Rezoning Transportation Analysis

Petition Number: 2020-013

General Location Identifier: 14902504, 14902503

| Date | Description |
|----------|--------------|
| 02-24-20 | First Review |

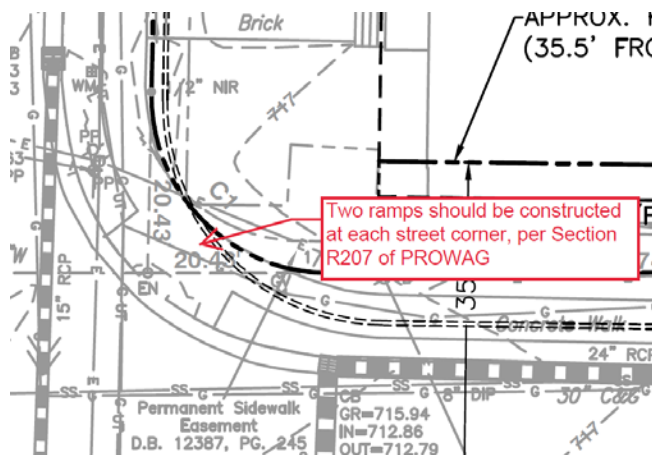
1. **Curbline** The proposed zoning district has a setback measured from back of the existing or proposed future curbline.
 - a. **South Tryon Street:** The future location of curb and gutter is 41 feet from road centerline, per the council adopted CDOT Streets Map.
 - b. **East Cama Street:** The future location of curb and gutter is 21.5 feet from road centerline, per the council adopted CDOT Streets Map.

The site plan should show the curb and gutter labeled and dimensioned from the centerline for each road.
